REMARKS

AMENDMENTS TO THE DRAWINGS

FIG. 1

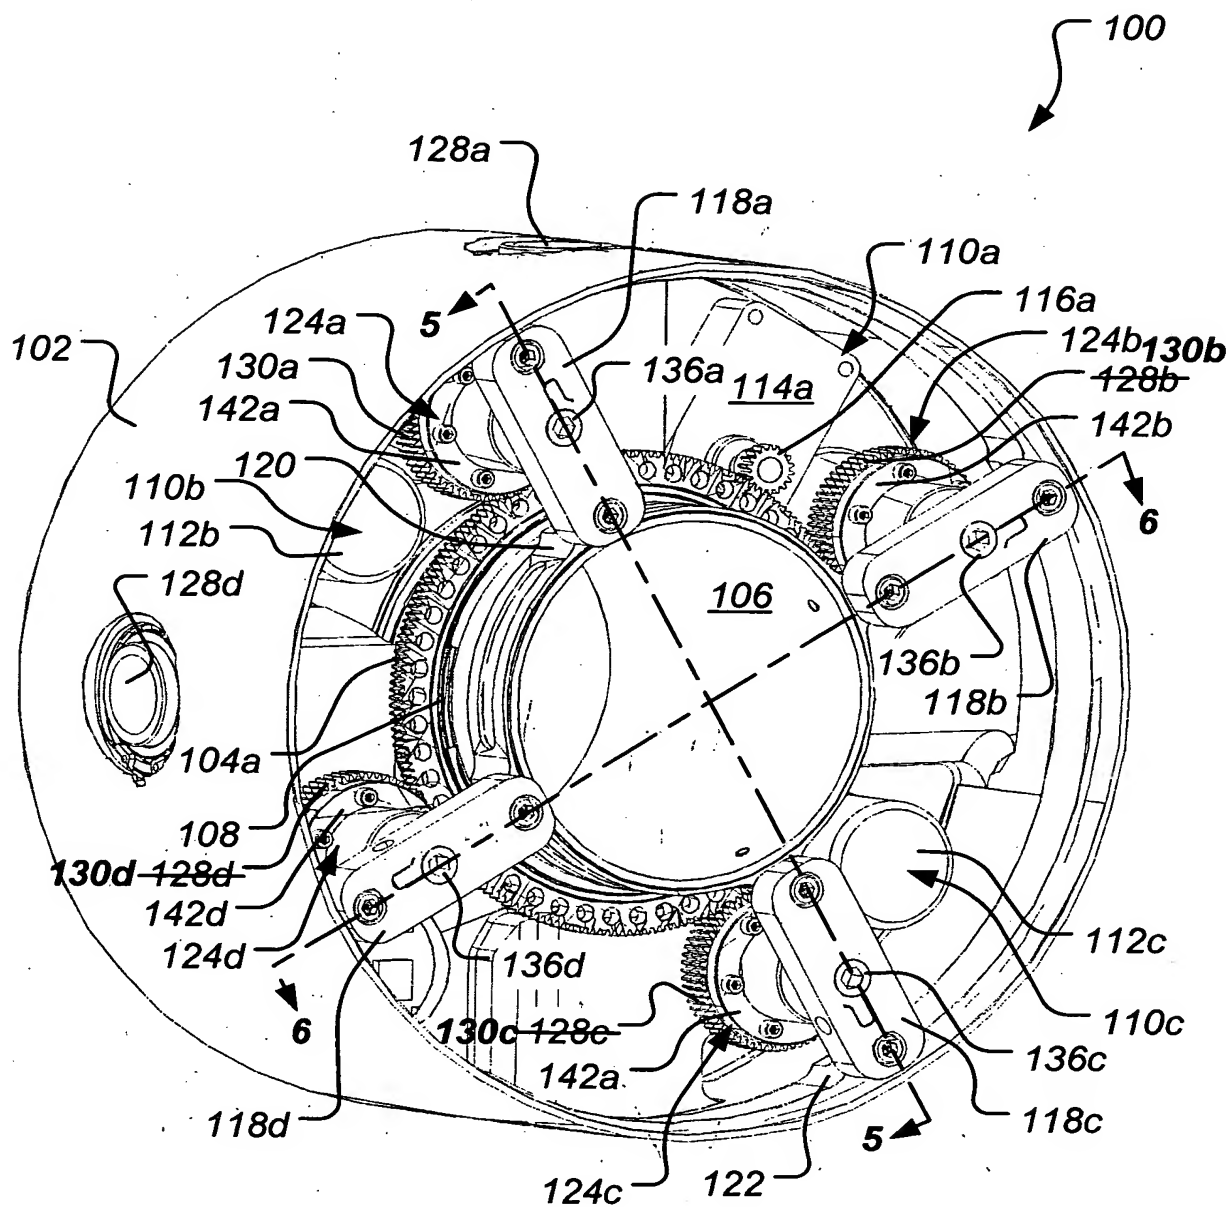
The Office Action indicates that the Drawings are objected to because reference characters "128b-128c" have been used to designate two different elements in Figure 1. Moreover, reference character "128d" has been used to designate two different elements in Figure 1. Accordingly, a new replacement sheet including Figure 1 is appended hereto, wherein 128b, 128c, and 128d have been changed to 130b, 130c,

and 130d, respectively. Accordingly, it is respectfully requested that the objection to the Drawings be reconsidered and withdrawn.

The attached sheet of drawings includes changes to Figure 1. This sheet, which includes Figure 1, replaces the original sheet including Figure 1. In Figure 1, element numbers 128b, 128c, and 128d, labeling roll gears, have been changed to element numbers 130b, 130c, and 130d, respectively.
